ADDENDUM DATE: December 21, 2023

ADDENDUM NO. 5

Cobblestone Manor
1050 Lamplighter Drive
Grove City, Ohio 43123

Addendum No. 5 to the Drawings and Project Manual, dated June 8, 2023, Cobblestone Manor as prepared by Moody Nolan, Inc., 300 Spruce St. Suite 300, Columbus, OH 43215.

3 DETAIL CASEWORK

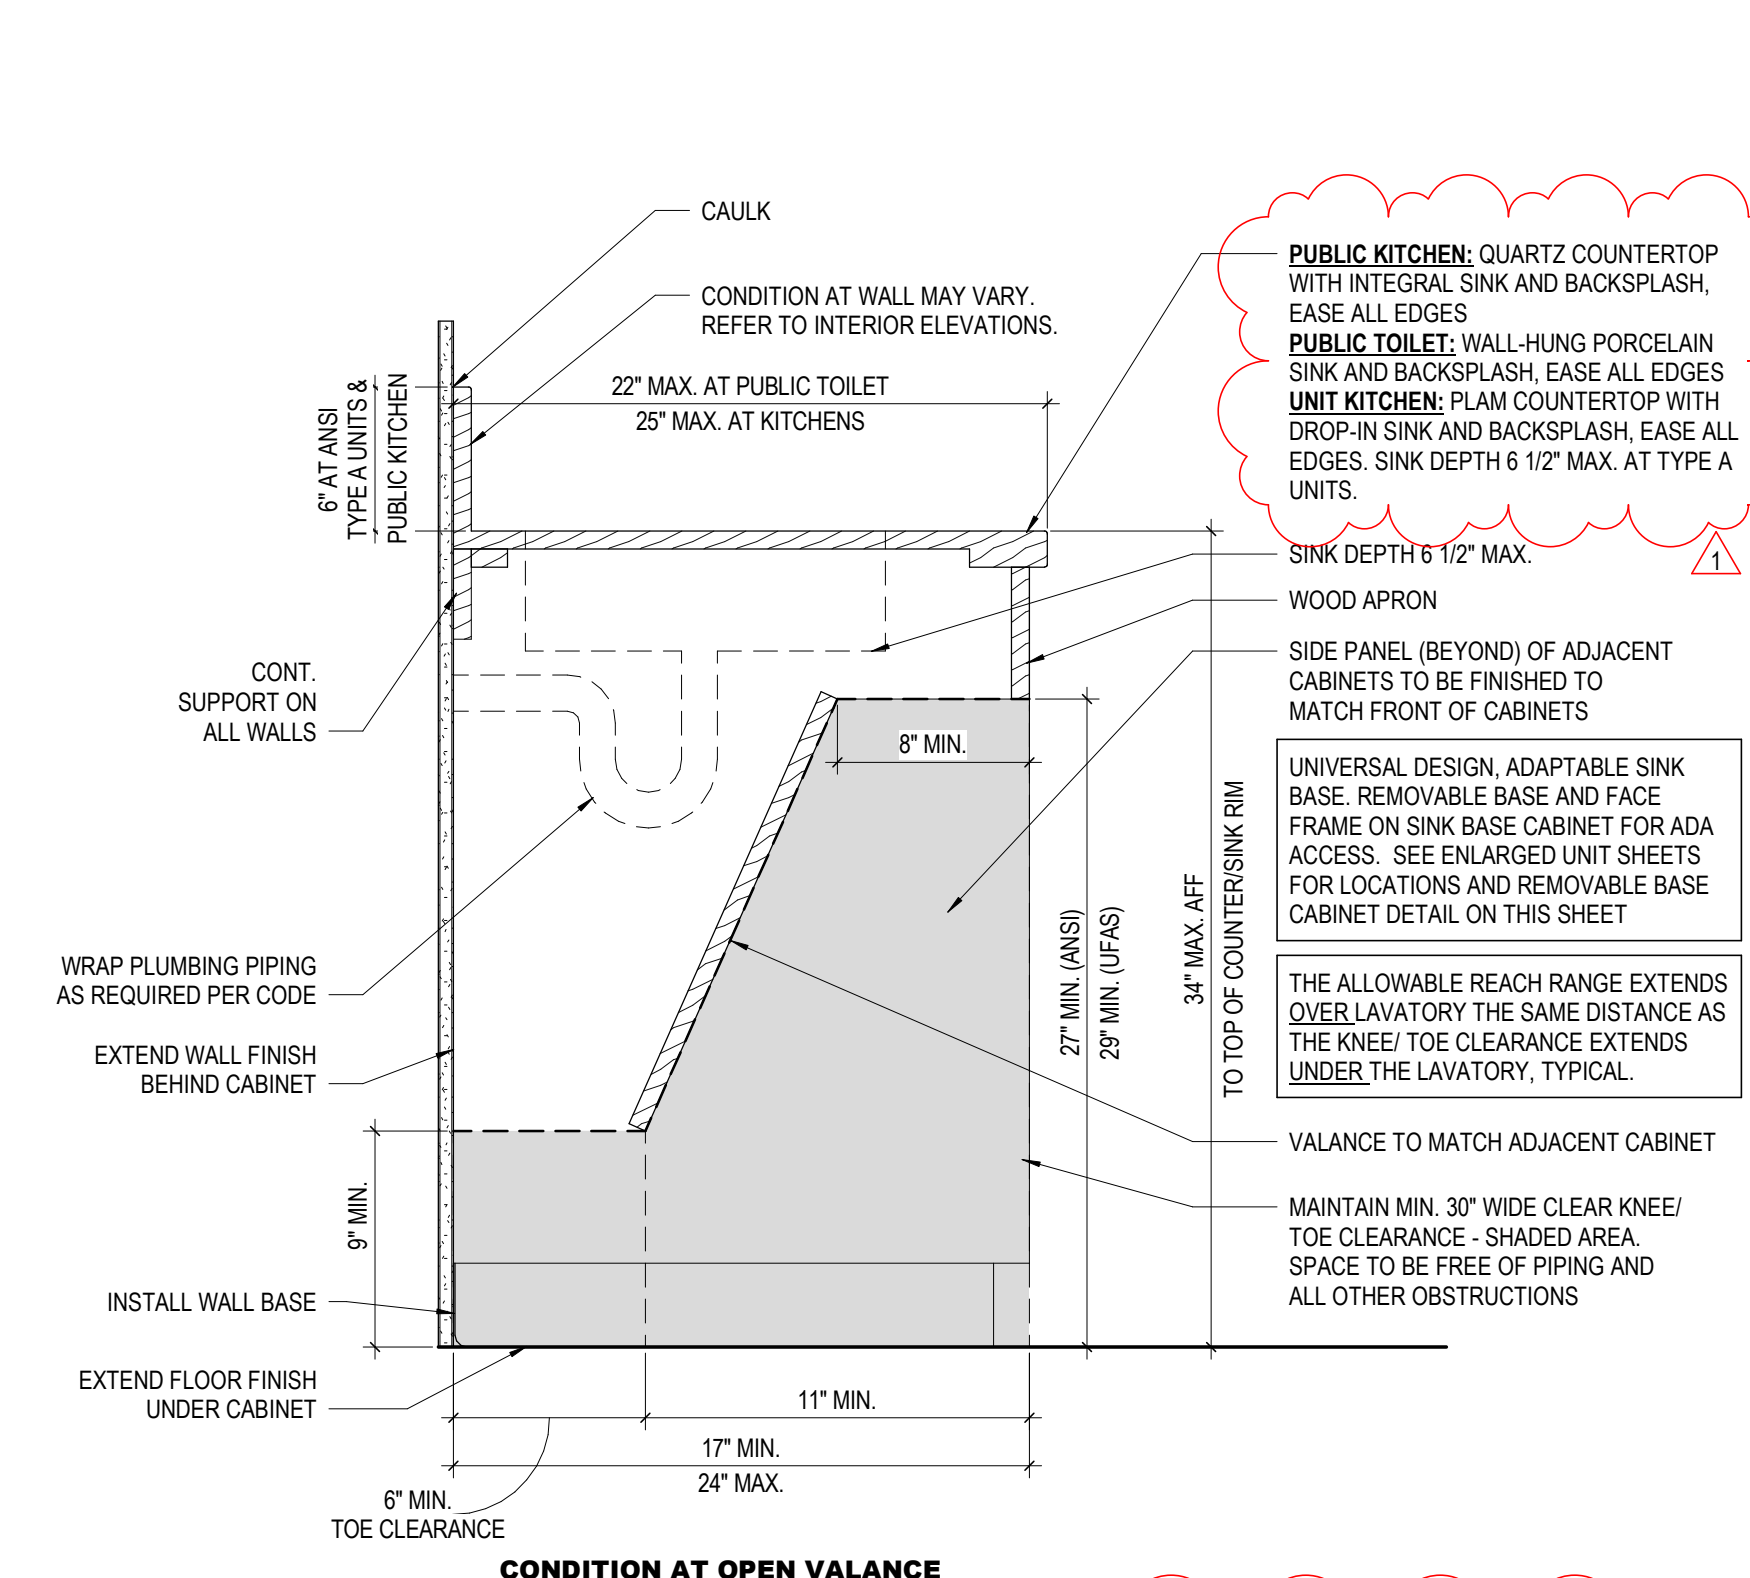
- j. A801 INTERIOR ELEVATIONS
 - 1. **REVISE** layout of Amenity Kitchen in Elevation 7.
- k. A810 TYPICAL PROJECT DETAILS
 - 1. **REVISE** Detail 3 to revise countertop materials.

06/08/2023
	DRAWN BY: Author CHECKED BY: Checker
	#22172.01
	P101A
PERMIT & BID SET

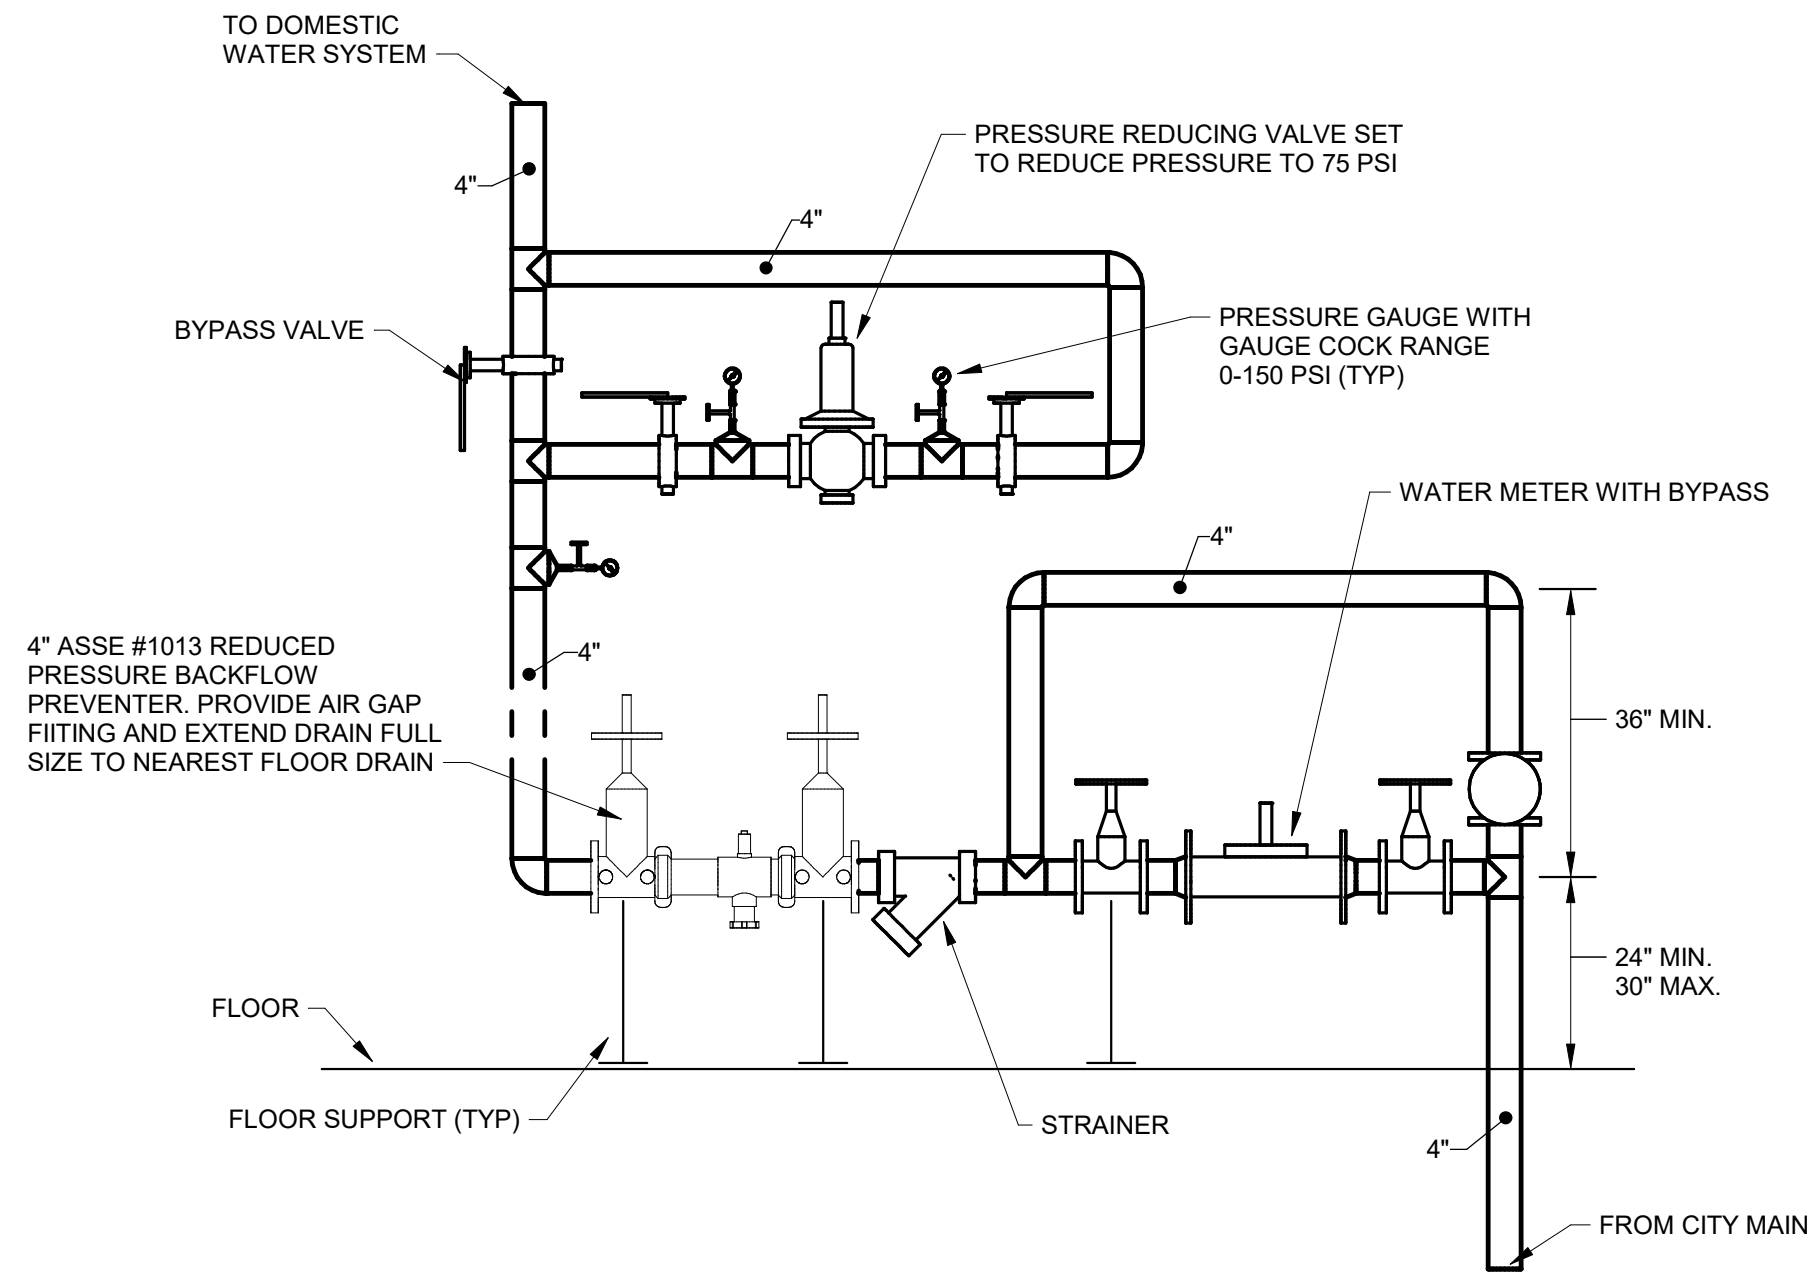
- l. P101A FIRST FLOOR PLAN - AREA A – PLUMBING
 - 1. **RELOCATE** the gas meter assembly and revise gas system.
- m. P501 DETAIL – PLUMBING
 - 1. **REVISE** Detail 4 – Gas Meter Assembly.
